**AGIP Addendum No. 1 for SMCL Sector 2 Northeast  
Expansion (11/26/2018)**

Re: Alternative Geotechnical Investigation Program – Addendum No. 1  
Advanced Disposal Services - Seven Mile Creek Landfill  
Sector 2 Northeast Expansion  
WDNR License # 3097

FIGURE NO.  
**3**  
 PROJECT NO.  
 180380

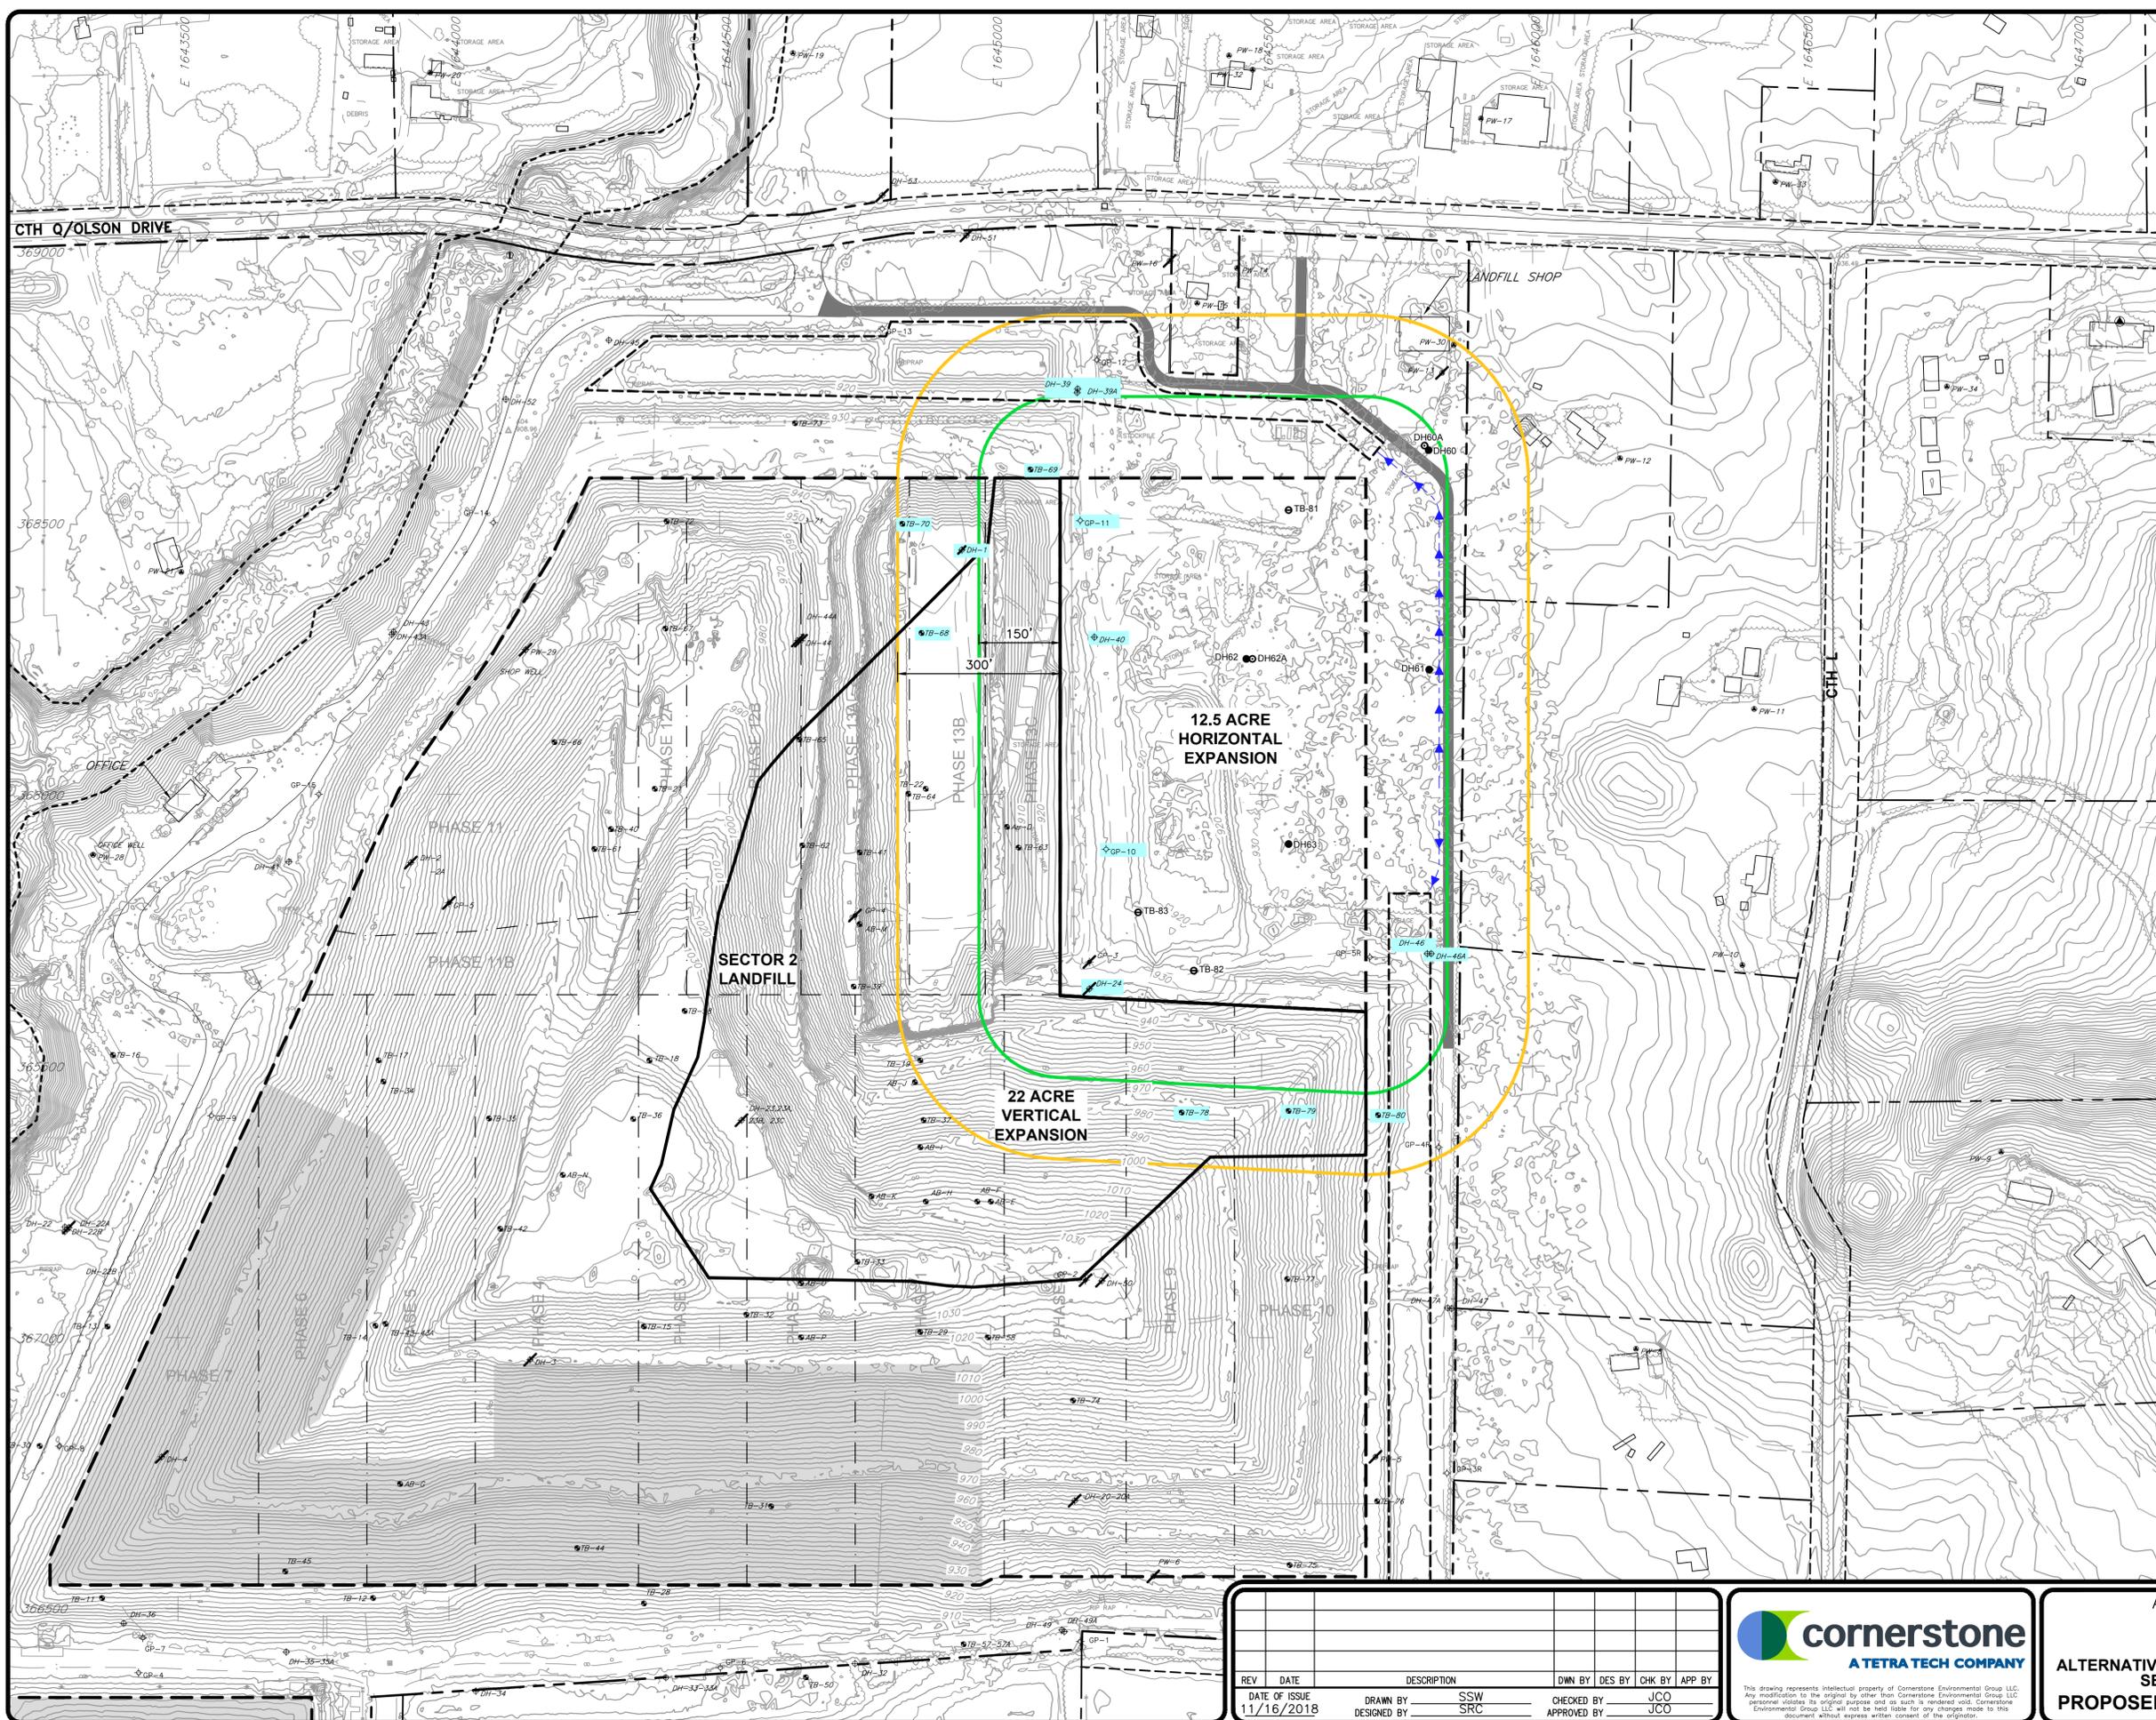
- a. We agree with footnote 1 of Table 1 of the proposal that the additional geotechnical work should focus on the 12.5-acre expansion area, since the other portion of the expansion is a vertical overlay on currently approved landfill area. To help us assess which borings/wells are located within the 150-foot and 300-foot perimeter distances from the horizontal expansion, we request that you submit a revised map showing these distances around the horizontal portion of the expansion, excluding the vertical overlay. This will help us verify which borings and wells would be considered as part of the AGIP for only the horizontal expansion.*

- b. Because the depth to bedrock is somewhat variable across the site and is shallow in some areas, we believe that some additional borings in the area of the horizontal expansion will provide improved fidelity of bedrock depth in this area. The area near the south-west end of the horizontal expansion includes an area shown on the bedrock map with deeper bedrock surface elevation from other areas onsite. It seems that this area has only a few borings to evaluate the data. Therefore, we are requesting either additional boring logs if they exist and/or additional new borings to better evaluate the bedrock surface and/or confirm its elevation is consistent throughout this area. We can assist in identifying possible locations for borings. We think that 2 additional borings in addition to the proposed 5 borings would improve the subsurface characterization if other existing logs are not available.*

**1a.** Figure 3 attached to the document, has been prepared that depicts the 150-foot and 300-foot off-sets from the 12.5-acre horizontal footprint. Additionally, Table 1 and Table 2 from the AGIP have been revised and are attached to this document to reflect the total number of existing and proposed borings and wells located within this setback area.

**1b.** The competent bedrock surface is variable across the eastern portion of the Sector 2 Landfill as evidenced by the assumed depth to competent bedrock noted at boring DH24 located in the southwest corner of the proposed horizontal footprint. As noted on the DH24 boring log included in the AGIP, approximately 30 feet of weathered bedrock exists at this location which creates the appearance of a bedrock depression at this location as shown on the Competent Bedrock Surface map included in the AGIP. Two additional borings (TB-82 and TB-83) are proposed to be drilled to the east and north of boring DH24 near the southwest corner of the proposed horizontal footprint. The locations of these two borings

are shown on Figure 3. These two new borings will be cored ten feet into bedrock to confirm the extent of the likely weathered bedrock surface.
